February 22, 1979
L-79-45

Re: St. Lucie Unit 1
Docket No. 50-335
Proposed Amendment to
Facility Operating License DPR-67

Re: St. Lucie Unit 1
Docket No. 50-335
Cycle 3 Operation

RELOAD SAFETY EVALUATION

FIGURE 3.2-4

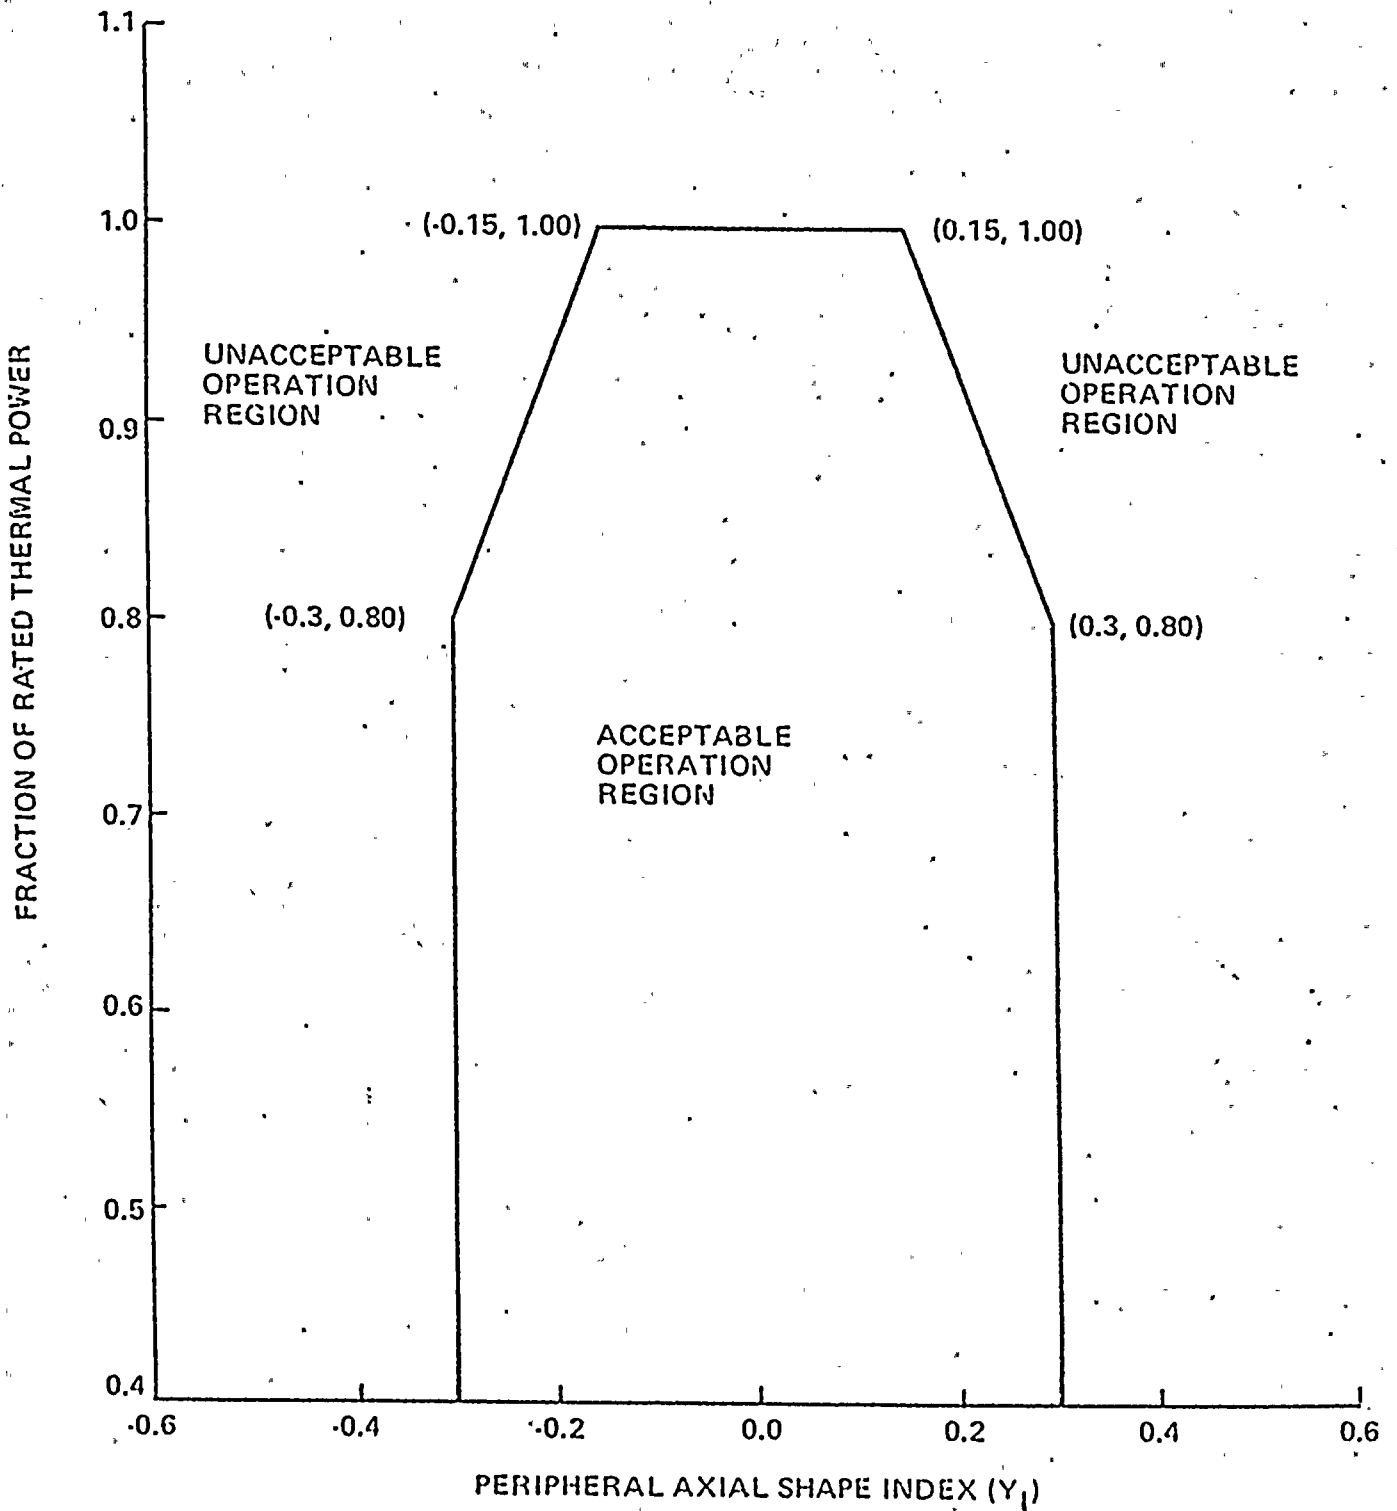
Figure 3.2-4 is revised based on the Cycle 3 analysis.
